**CHARLOTTE DOUGLAS INTERNATIONAL AIRPORT  
CHARLOTTE, NORTH CAROLINA**

**ADDENDUM NO. 2**

**NORTH END AROUND TAXIWAY (NEAT)  
OVERLOOK RELOCATION**

**CLT PROJECT NO. AVIA 23-50  
ADDENDUM DATE: MAY 25, 2023**

SHT.  
**X-1**

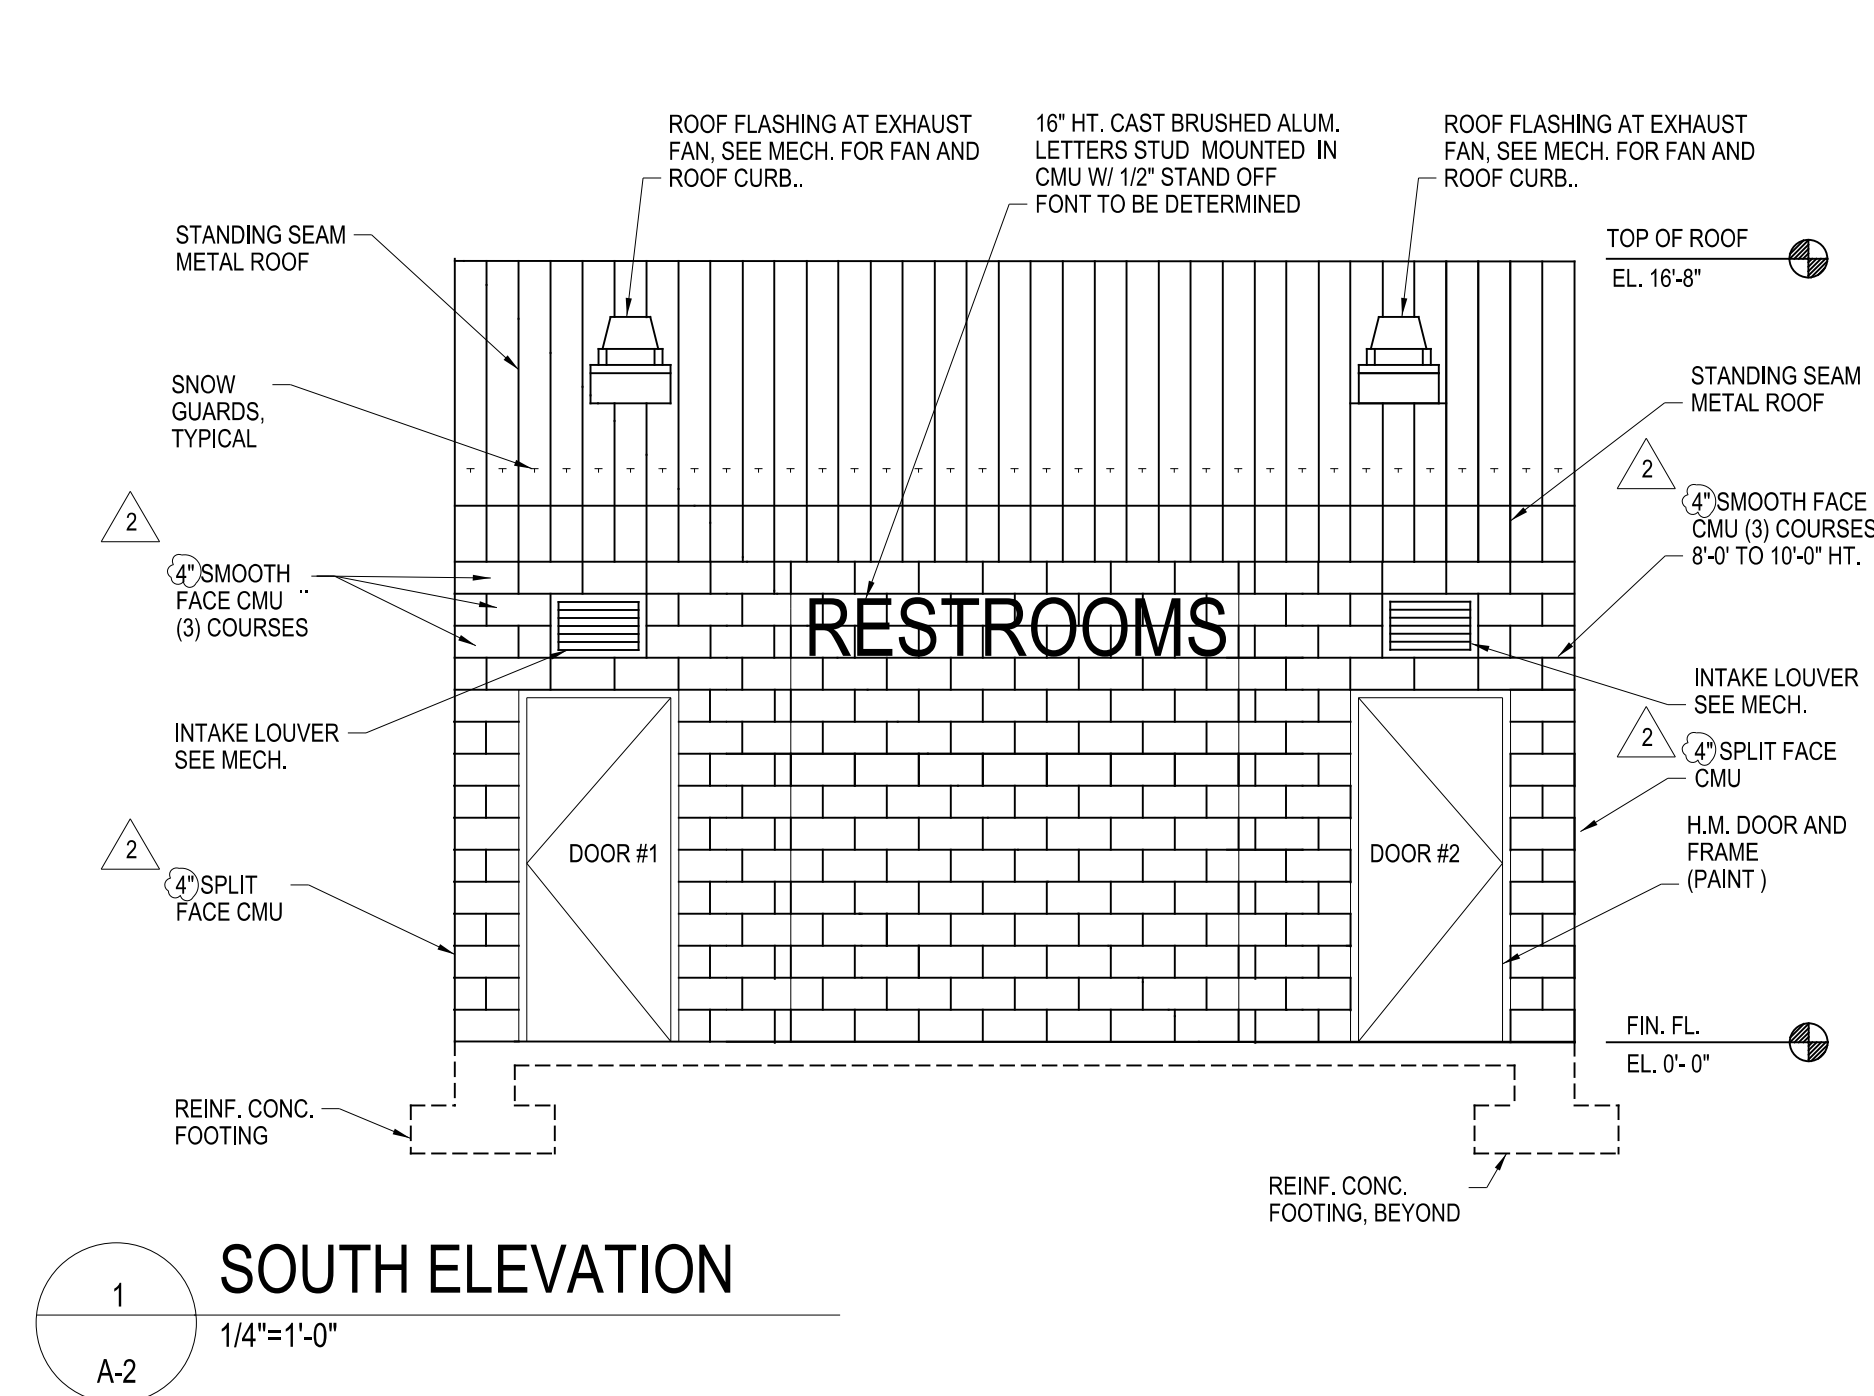
REVISIONS		DATE
1	ADDENDUM NO. 2 - REVISED EARTHWORK NOTE	05/25/2023
2		
3		
4		
5

NOTE: QUANTITIES ARE APPROXIMATE ONLY. THE CONTRACTOR WILL PROVIDE THE RESIDENT PROJECT REPRESENTATIVE AN INITIAL SURVEY PRIOR TO BEGINNING WORK AND A FINAL SURVEY TO BE USED TO COMPUTE THE FINAL QUANTITIES FOR WHICH THE CONTRACTOR WILL BE PAID. THE INITIAL SURVEY, FINAL SURVEY AND QUANTITY CALCULATIONS ARE INCIDENTAL TO UNCLASSIFIED EXCAVATION.
